# Report on East Kentucky Power Cooperative's 2022 Integrated Resource Plan

**Kentuckians for the Commonwealth**

**October 2022**

**(Revised October 28, 2022)**

**Figure 1. EKPC Summer Peak Demand 2012 – 2036, Actuals through 2020**

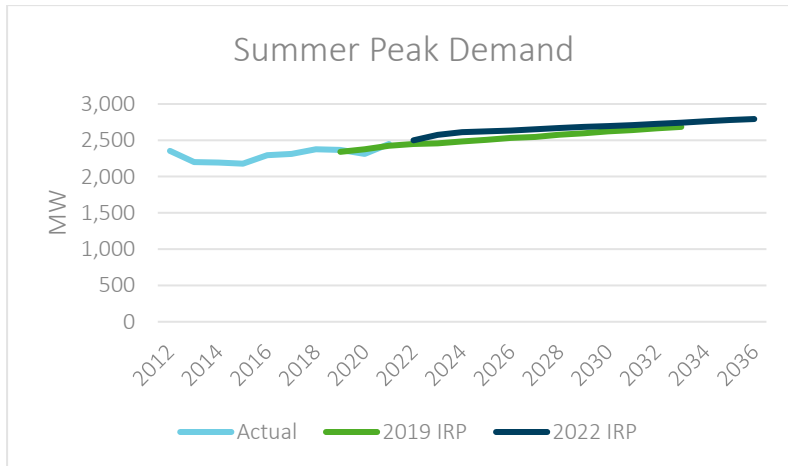
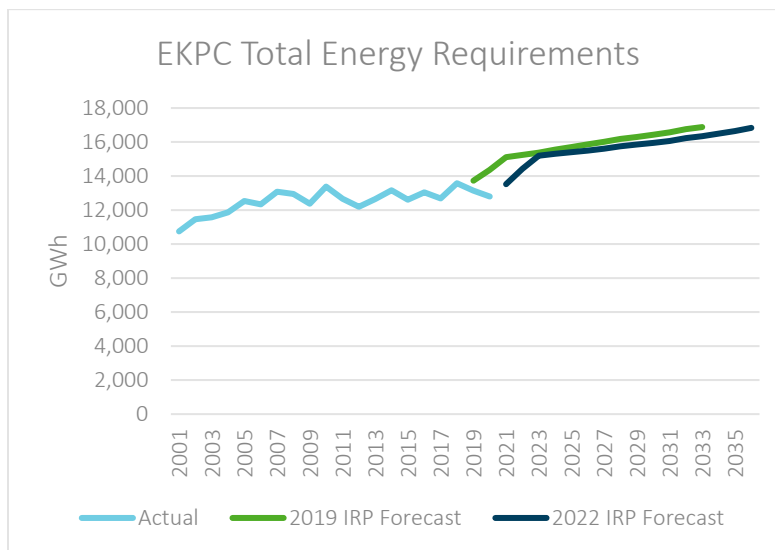
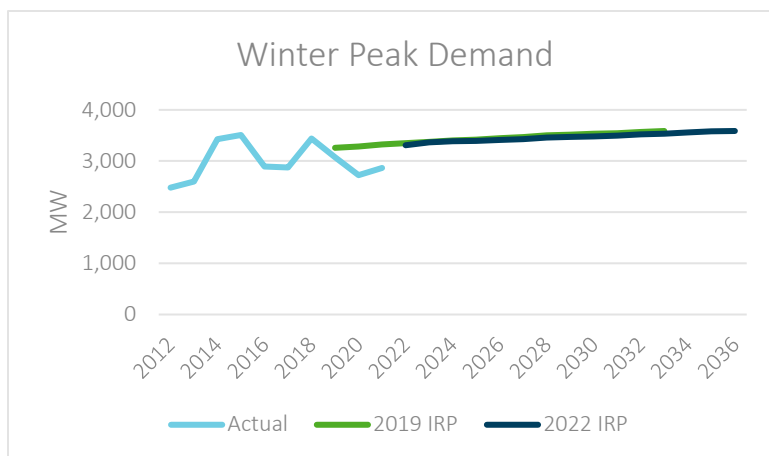
EFG compared the historic growth rates of the Cooperative’s seasonal peaks and total energy requirements to the projected growth rates. Below, in Table 1, are the Compound Annual Growth Rates (CAGR) calculated for the summer peak, winter peak, and total energy requirements, respectively. The growth in EKPC’s seasonal demand peaks and total annual energy requirements over the previous 10-years has been flat to declining for EKPC.

The forecasted growth rates in energy requirements should be explained by EKPC. No explanation was provided by EKPC that would indicate the change is related to methodological changes or exogenous factors.<sup>8</sup> Certain refinements to consider may be shortening the load and weather history used to estimate the models. Additionally, given the structural reality of the Cooperative's load forecast for this IRP, it may provide additional value to regulators and stakeholders if EKPC used a more updated load forecast even as a sensitivity in future IRP filings.

**Figure 4. PJM Forecast of EKPC Zone Summer Coincident Peak and Winter Peak<sup>10</sup>**

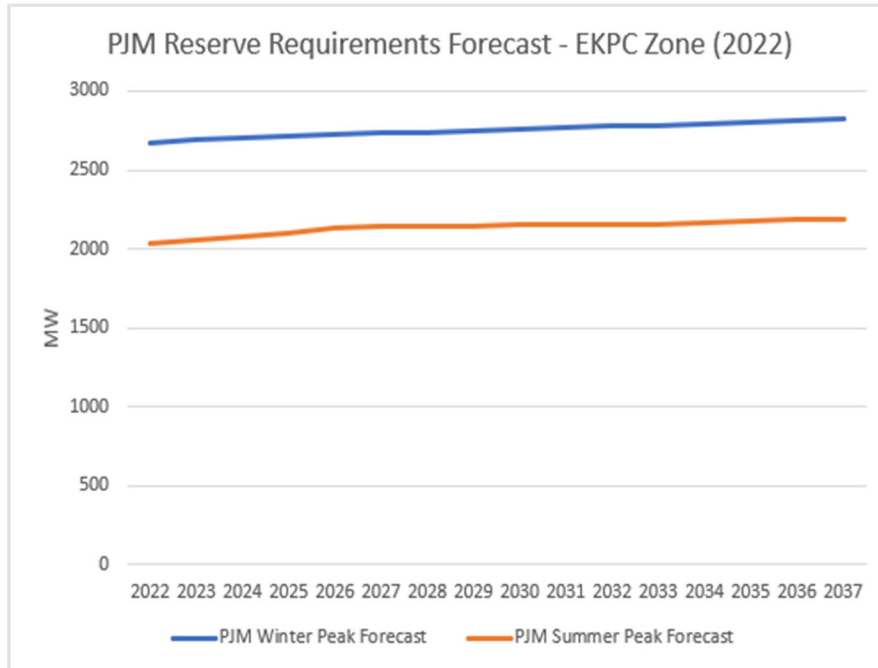
Further, as a member of PJM, EKPC is positioned beneficially. The utility can meet its summer peak with its own resources and procure excess energy from PJM’s markets during the winter. For comparison, EKPC projects it will have approximately 3,600 MW of generating capacity through 2036, without the anticipated 395 MW of capacity additions. PJM projects that EKPC’s zonal load obligation will peak at approximately 2,200 MW in 2036. Figure 4 above, graphs PJM’s expectation of the seasonal peak demands in the EKPC zone.

We further note that EKPC’s next IRP would benefit from more forthright explanation of how their forecasting method necessarily differs from that of PJM, and to what effect. PJM’s forecast in the EKPC zone and EKPC’s own forecast do differ, and EKPC did analyze that difference. According to EKPC, there are several reasons why the PJM load forecast and its internal load forecast are not directly comparable to each other. But those differences and EKPC’s analysis are not clear on the face of the IRP and needed to be drawn out through independent investigation and information requests. EKPC provided an explanation of the difference between its forecast and PJM’s. However, this is a missed opportunity for

**Figure 6. EKPC Forecast of Coal Prices**

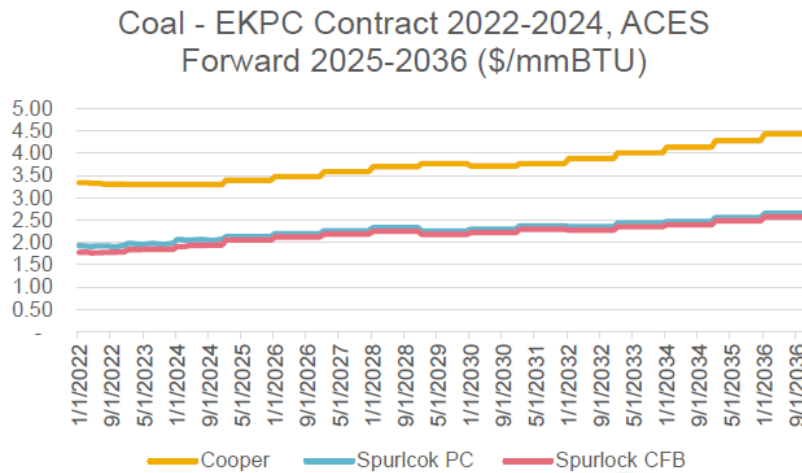
EKPC provided its coal price forecast in a graph, reproduced as Figure 6 below, for its delivered coal contract price forecast. The chart presents a relatively flat growth rate for the price of delivered coal to both of its units. The price of delivered coal for the Cooper Station and Spurlock Station Units diverge significantly. This may be because, according to S&P Global,

Spot market coal prices have increased significantly since EKPC made its projection of future contract prices, and EKPC’s forecast of delivered coal prices is unrepresentative of recently executed contracts executed.<sup>20</sup>

Coal market pricing data are less readily available than data in other commodity fuel markets. Thus, transparency in the Cooperative's coal price forecast assumptions and the development of that forecast is essential to an informative IRP process. For example, only Spurlock Station's coal contracts were provided through discovery.<sup>21</sup> In future IRPs, EKPC should provide its coal contracts for Cooper Station as well. In addition, EKPC should explain how it developed its forecast of these prices and provide the data in an accessible and disaggregated format for stakeholders to evaluate.

**Figure 7. EKPC Natural Gas Forecast vs Current NYMEX Curve**

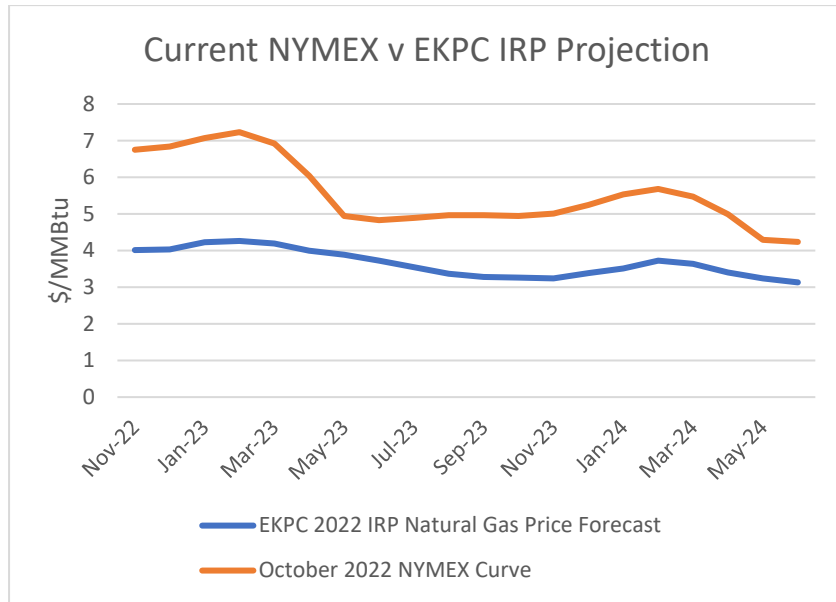
Natural gas prices forecast in EKPC's IRP, and reproduced below from December 2022 through June 2024 with the most recent NYMEX futures curve, as Figure 7, are also concerning. Likely due to the vintage of the forecast, EKPC is projecting the NYMEX Henry Hub price to drop dramatically below current market levels and forward projections. December 2022 is in the forecast period for the natural gas price assumptions in 2022 IRP. EKPC projected natural gas prices to be approximately \$4/MMBtu at this time. Henry Hub futures are currently trading at nearly \$7/MMBtu, an increase of 75% over the Cooperative's modeled assumption. Although trading is thin, the NYMEX forward curve is consistently above \$4/MMBtu and near \$5/MMBtu through 2024.<sup>22</sup> The NYMEX forward curve is readily available, and in future IRPs, we recommend that EKPC use the most recently available NYMEX curve or an approach that blends the near-term NYMEX trend with long-term fundamentals forecast.

**Figure 8. EKPC Forecast of Energy Market Prices**

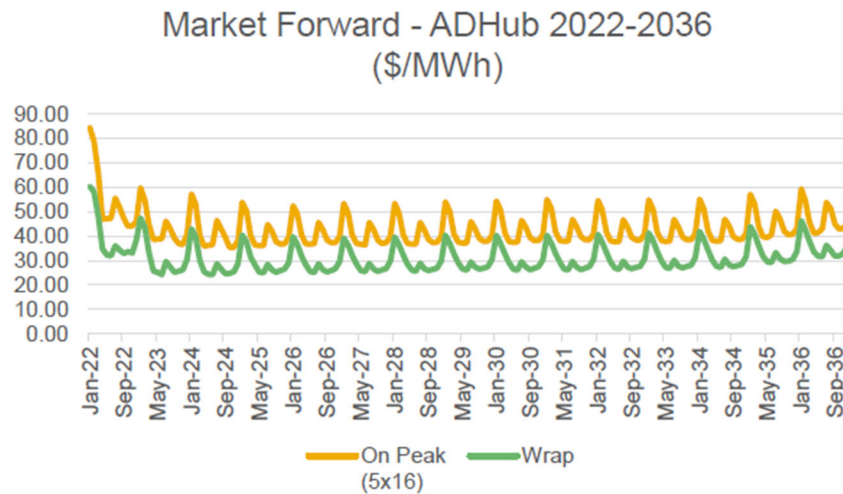
EKPC’s energy market price forecast, reproduced above as Figure 8, is also low as compared to observed market prices. For example, the year-over-year average PJM AEP-Dayton Hub Locational Marginal Price (LMP) was \$63.37/MWh from September 1, 2021, to September 1, 2022. Thus far for 2022, the year-to-date average PJM AEP-Dayton Hub LMP has been \$71.24/MWh. The current average of PJM AEP Dayton Hub LMPs for September 2022 is \$82.28/MWh.<sup>23</sup> This is far above the forecasted energy market prices for both the forecasted contract prices.

**Figure 13. EKPC Modeled Net Purchases (MWh)**

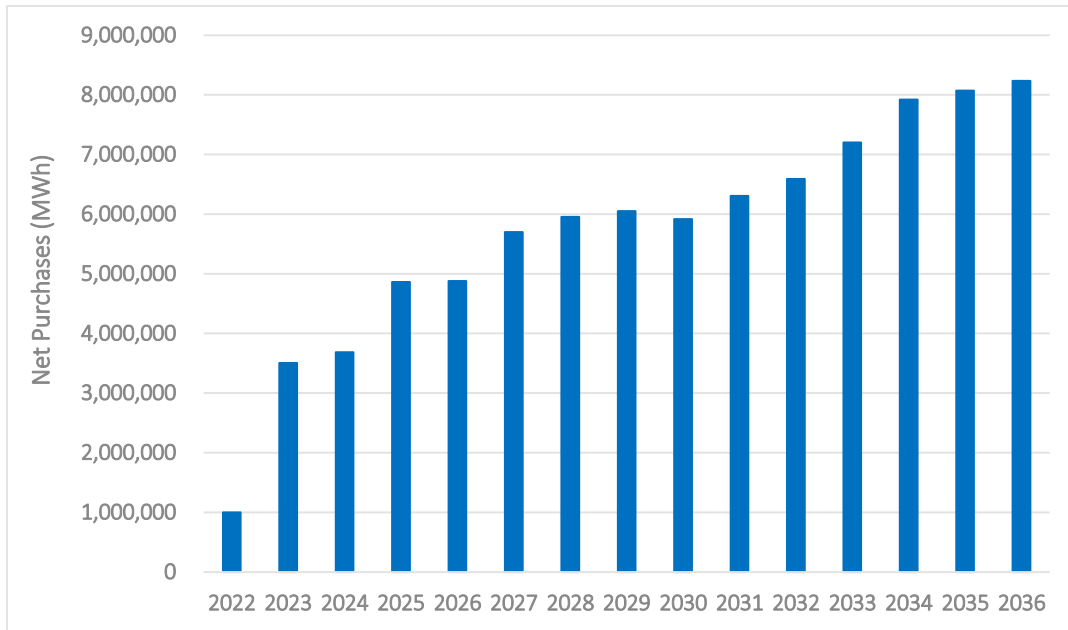
In combination with the [REDACTED] in the operations of the Cooper units, EKPC is forecasting higher energy requirements, which means that EKPC expects that a decreasing proportion of its needs will be met by its own generation. In order for the model to meet the energy requirements and not have any shortfall periods, the model purchases more energy from the market. Figure 13 shows the modeled net purchases for EKPC over the planning period, which indicates an increasing level of market purchases.

In response to Joint Intervenor Request 49, EKPC stated, “EKPC hedges its exposure to high market prices by ensuring it has adequate resources to cover its load. When the market prices are lower than EKPC’s resources, then EKPC purchases from the market and its resources are not dispatched. When the PJM market price is higher than the EKPC resources, then the EKPC generating resources are dispatched into the market. This allows the EKPC owner-members to be hedged against the high market prices.”

**Figure 18. Participation by Program**

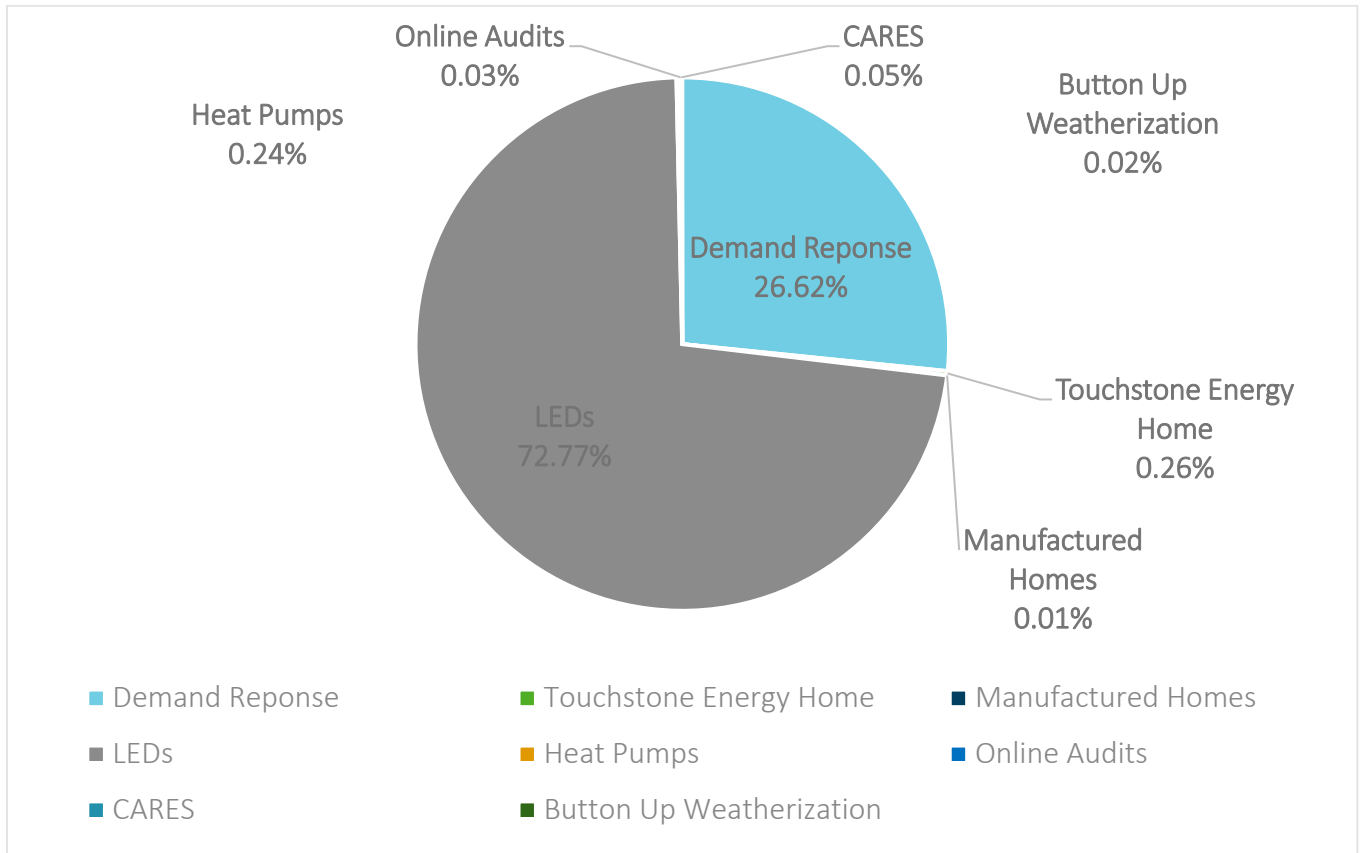
EKPC's residential DSM programs have minimal participation per year when compared to the total number of customers. Figure 18 below shows the level of participation by program. LEDs and demand response contribute almost all of the 2021 participation, with all other programs accounting for 0.61% of participation.

Outside of the LED and the demand response effort, the Heat Pump Retrofit Program and Button-Up Weatherization programs are the only programs that implement energy efficiency in existing homes. The CARES, Touchstone Energy Home, and Manufactured Homes programs rely on the cooperatives working with CAAs and manufacturers/builders, respectively. Based upon the breakdown in Figure 19, this means that only 44% of the 0.61% of the participation identified in Figure 18 is with owner-members. The reason for the lack of participation in the energy efficiency programs is likely two-fold. First, as identified above, the rebates are for minimum efficiency standards and therefore do not support the adoption of more efficient technology. There is no incentive for customers to choose higher efficiency options and the

**Figure 19. Participation Excluding LEDs and Demand Response**

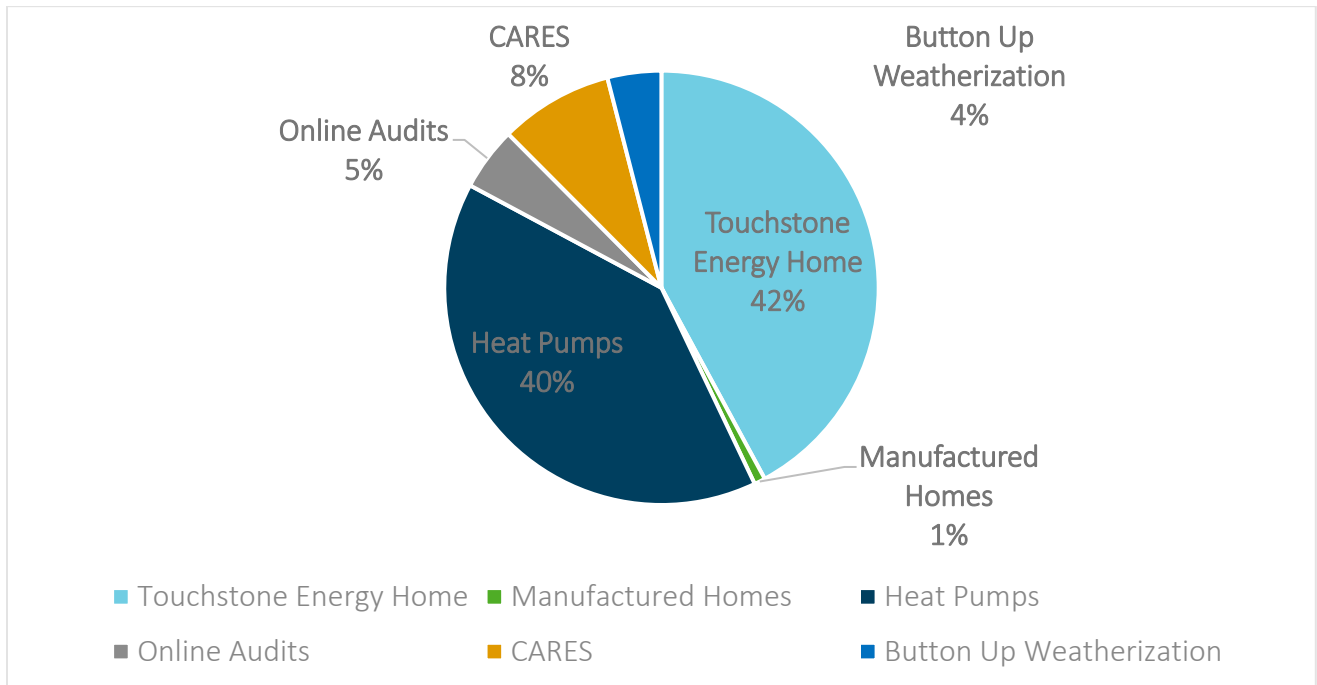
rebate levels are not offsetting the cost of the higher efficient technology. Second, there is a lack of marketing of the energy efficiency and demand response programs.

**Figure 20. EKPC's Energy Efficiency Webpage**

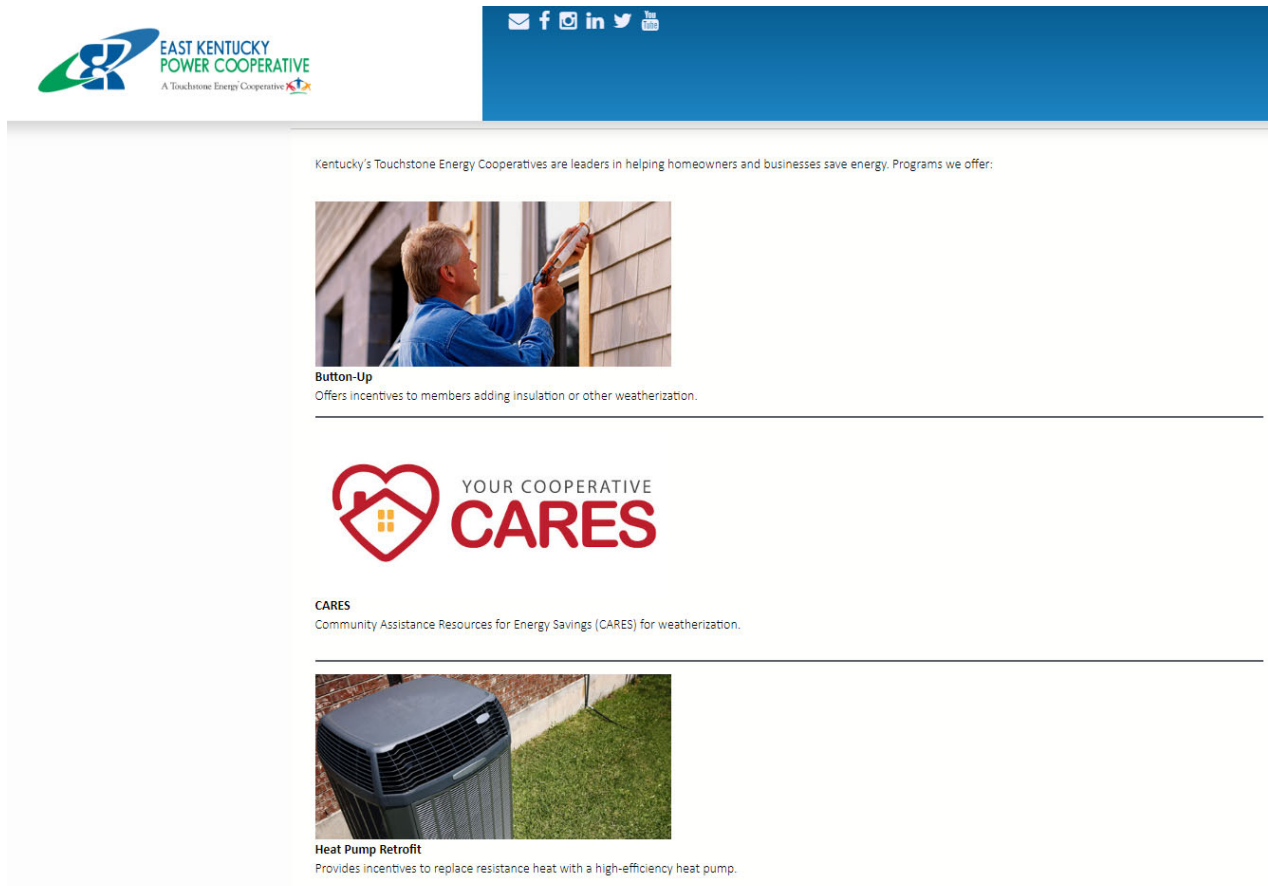
One recommendation is to increase the content on EKPC’s energy efficiency webpage. This page includes a list of the programs with a one-sentence description. However, it lacks information on how to participate in the programs, rebate levels, eligible contractors and measures, and the benefits of energy efficiency. At a minimum, EKPC should revise its website, referenced in Figure 20, to include the information identified above and provide links to its member cooperatives to allow for members to find out how to participate.

In addition to the website, EKPC could create streamlined marketing materials for its member-owners to utilize to promote the programs at various community events, mailings, and annual meetings. The materials could be customized with the logo of the member cooperative, along with EKPC. This would be a way to extend marketing funds further and would be an economical way to increase program participation and savings.
